Date: December 20, 2005 **PCN No.:** PCN # 033

Product Change Notice: XPort Firmware Version 6.1

Revision Tracking Information on XPort Label

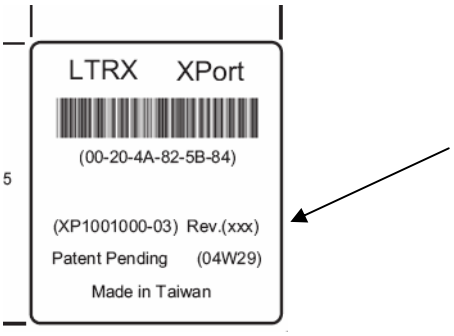
For quality and tracking purposes, the manufacturing revision numbers on the product label will be changed. New revision numbers are also listed in the table.

Please note that the revision information for the XPort product is as shown below:

XPort factory shipments with firmware 6.1.0.0 will begin January 31, 2006. The firmware version can be verified by examining the label for the product revision number.
